## **BCA ASSESSMENT REPORT**

**OAKDALE SOUTH ESTATE  
SITE 3B - TOYOTA  
MILNER AVENUE, HORSLEY PARK**

**PREPARED FOR:  
GOODMAN PROPERTY SERVICES (AUST) PTY LTD**

Revision 1

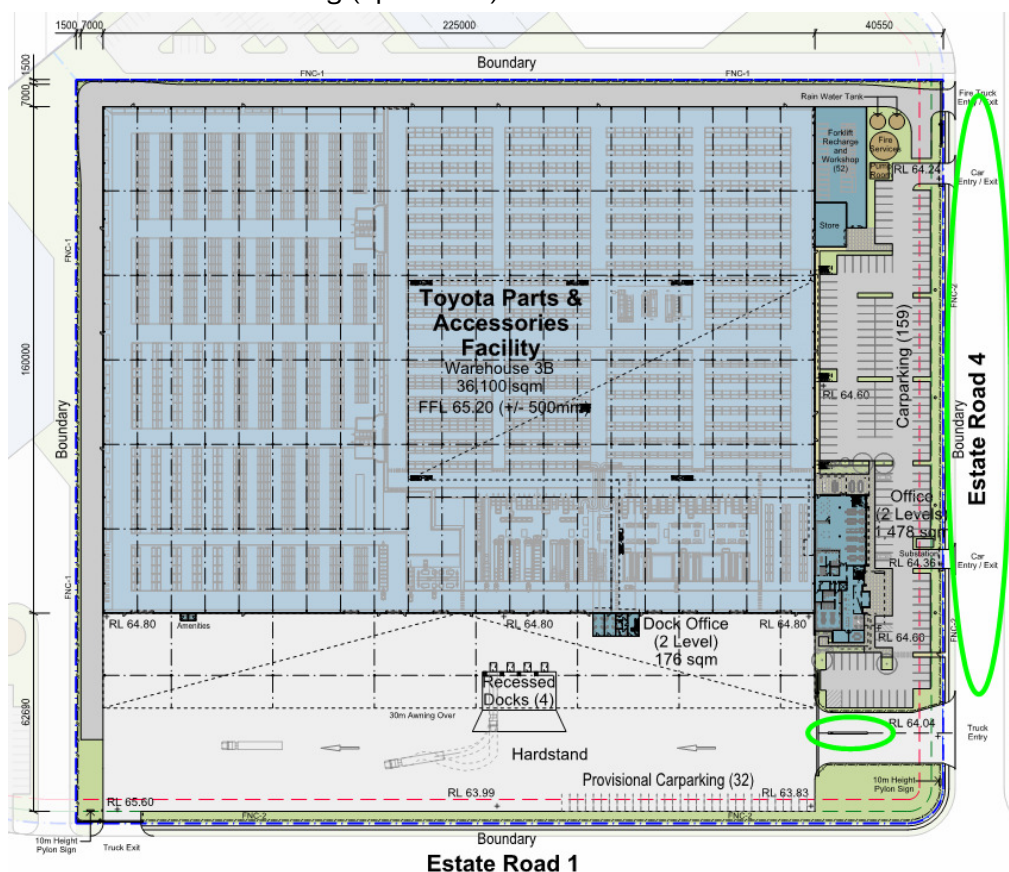
*Comments: It will be necessary for an alternative solution to be prepared to address these non-compliance issues below, in order to demonstrate compliance with Performance Requirement CP9. The departures from this clause are as follows:*

- + The vehicle access on the Northern side and the NE corner of the building is greater than 18m from the building (up to 53m) as circled below.
